Bulletin No: 562-80006-00
Issued: August 30, 2007

Subject:	Fan Voltage Arrestor
-----------------	----------------------

Model Numbers Affected:	RHS730 and RHS780 refrigerant recovery and recycling equipment
Manufacture Dates:	January 2005 through September 2006
Serial Numbers Affected:	Middle six digits (Day-Month-Year) indicated between above dates
Tools Required:	Screw Driver
Parts Required:	Voltage Arrestor Assembly P/N: 360-81211-01 (110 VAC) or 360-81211-02 (220 VAC)
Supplemental Document:	None
Action Required:	Verify that Voltage Arrestor is installed on any of the above models. Install Voltage Arrestor if required.

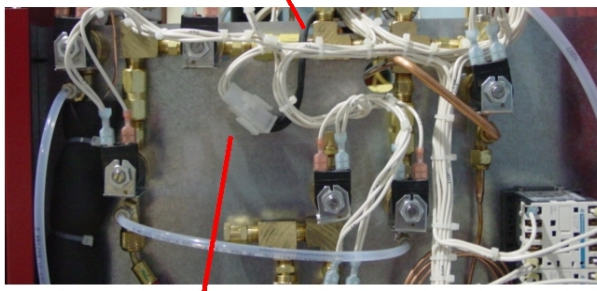
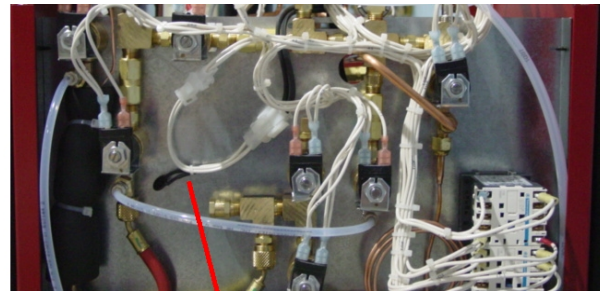
RTI has recently experienced a few occasions where electrical noise from the condenser fan motor may damage the control circuit board.

We ask that if you are on a service call for **any type of RTI equipment** that you inquire if the customer has an RHS730 or RHS780. Check the serial label (serial number format xxxxxx-DDMMYY-xxx) to determine the date of manufacture. The middle six digits show a date code (Day-Month-Year). If the serial number indicates the unit was manufactured from January 2005 through September 2006, remove the front plastic cover and determine if a voltage arrestor was installed on the condenser fan motor. If not, please make arrangements to install one. Contact RTI to report the need to install one.

Voltage Arrestor not installed

Voltage Arrestor installed

Trace the black wire back to the condenser fan motor to determine where the Voltage Arrestor should be installed. The Voltage Arrestor is integral to a small wiring harness which can easily be installed as shown in the photo above.
